Application no: R3.0138/21

Location: HIF 1 Project

## **Lead Local Flood Authority**

## Scheme Wide Drainage Strategy Report - Project number: 60606782

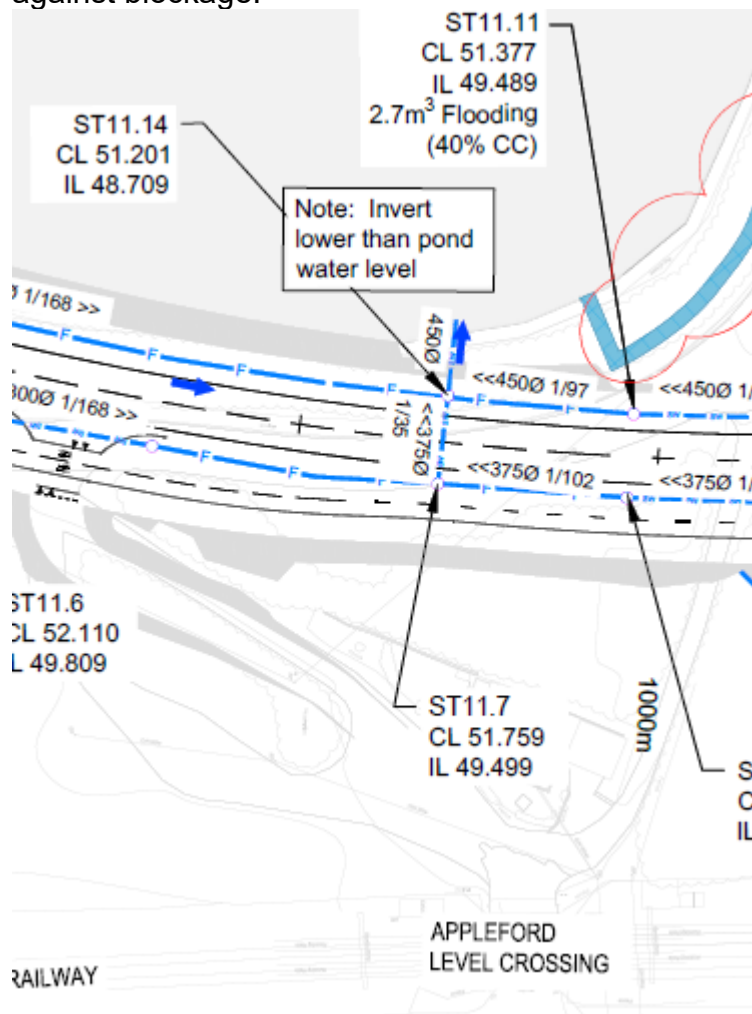
Basin design - Low flow channels should be included through basins. Sediment forebays should be incorporated within basins.  
Adequate access for maintenance vehicles to be detailed.

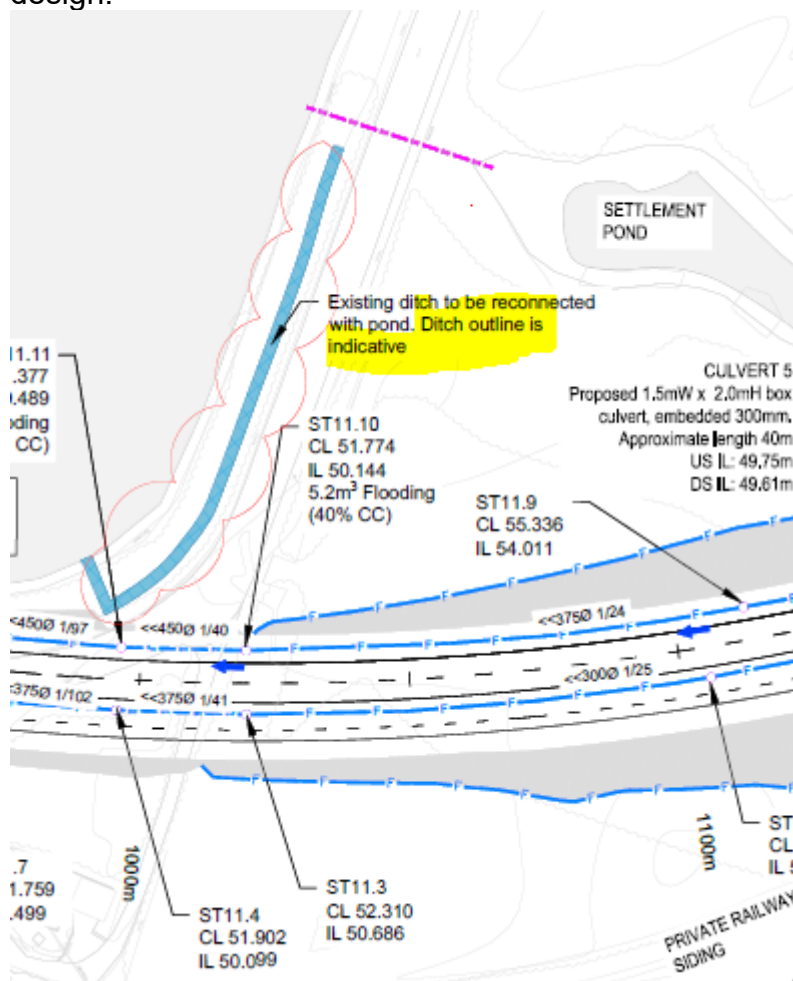
Invert lower than pond, thereby system will be operating in surcharge, at detailed design this should be reviewed to include relevant SuDS measure to remove surcharge risk, e.g over-edge drainage, shallow swale or ditchline including design against blockage:
